NAPLES BEACH RESTORATION AND WATER QUALITY IMPROVEMENT PROJECT

QUESTIONS FROM CITY COUNCIL
SUBMITTED FEBRUARY 2020

CITY OF NAPLES
STREETS & STORMWATER DEPARTMENT
295 RIVERSIDE CIRCLE
NAPLES, FL 34102

Figure 1: Depiction of a double valley gutter inlet directly over a 36-inch diameter storm sewer pipe.

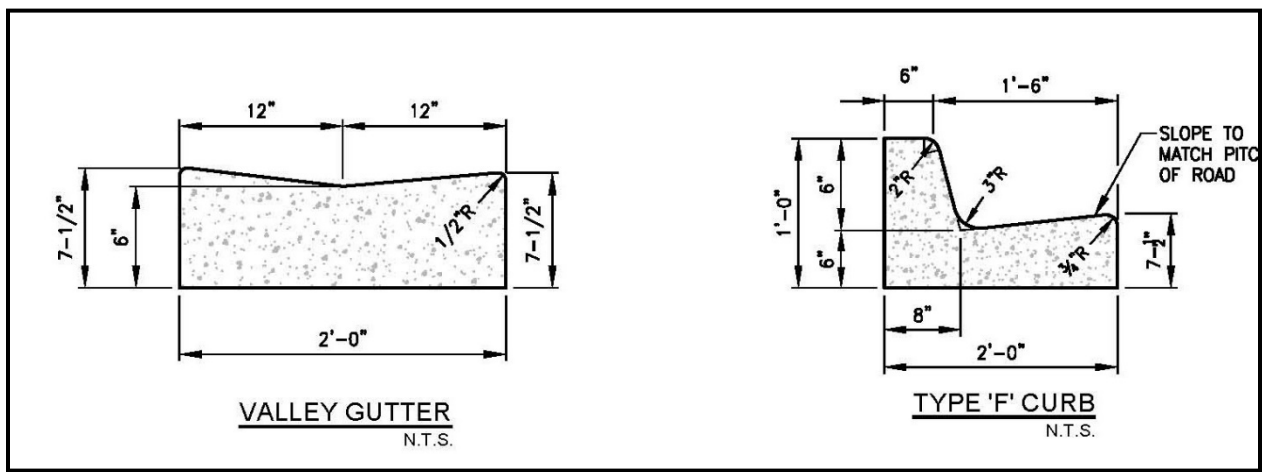
- **Will the project typical sections be updated to illustrate accommodation of all infrastructure (buried electric, water, sewer, reuse water/effluent, buried telephone, buried cable television, gas, drainage/stormwater, street lighting, sidewalk, bicycle accommodation, curb, pavement, and landscaping)? The constrained conditions become clearer. (Council Member Hutchison)**

RESPONSE: Yes, the cross sections will be updated. The cross sections will show the utility information that is pertinent to the project and available to the City.
